April 10, 2014

**CITY OF RANCHO MIRAGE  
ADDENDUM NO. 4**

**WHITEWATER PARK EXPANSION AND AMPHITHEATER PROJECT  
NO. CP 12-284**

# NYLOPLAST DRAIN BASIN WITH WEIR

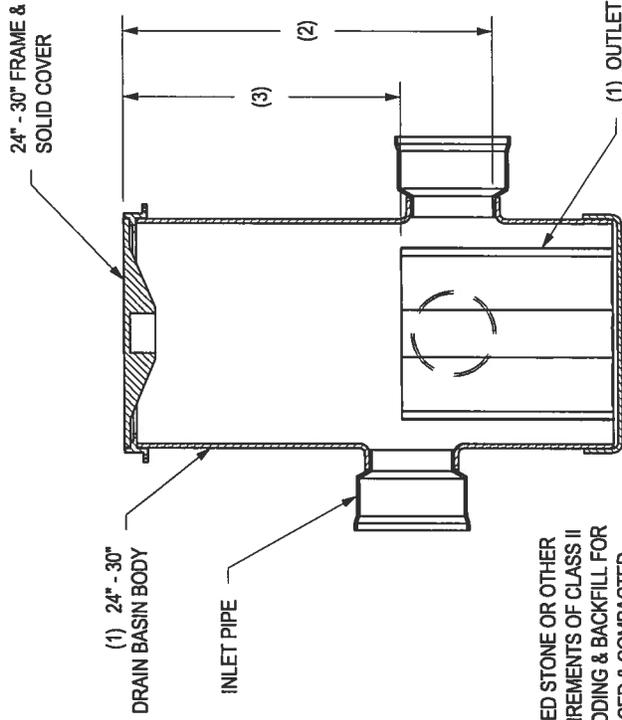
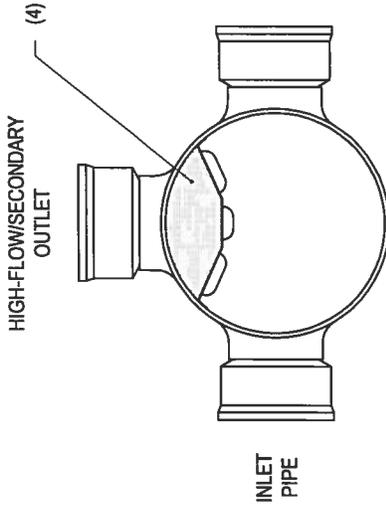
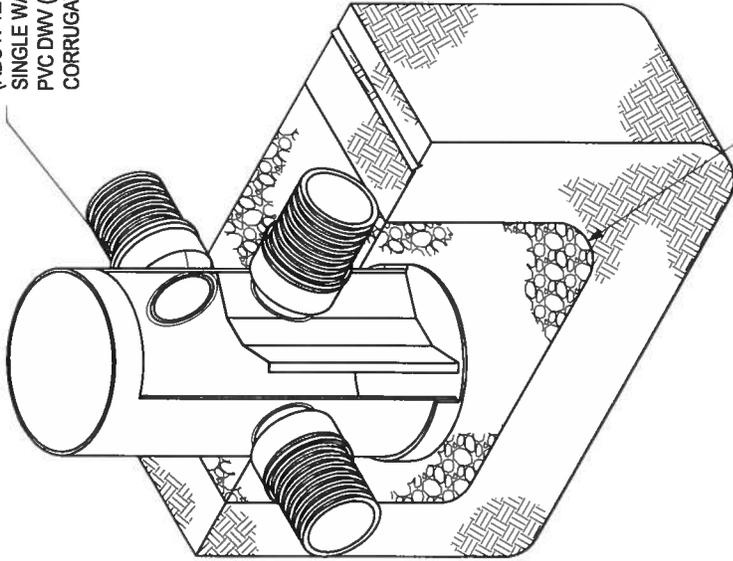
13. All storm drain pipe 6"-24" shall be ADS N-12 ST IB (soiltight) pipe.
14. Storm Drain Note #75 on Sheet C11, ADS 24" Weir Structure shall be Nyloplast Drain Basin w/Weir (part no.7004-110-058). See attached manufacturer's detail or web site <http://www.nyloplast-us.com/sites/default/files/resources/pdf/7004-110-058.pdf>
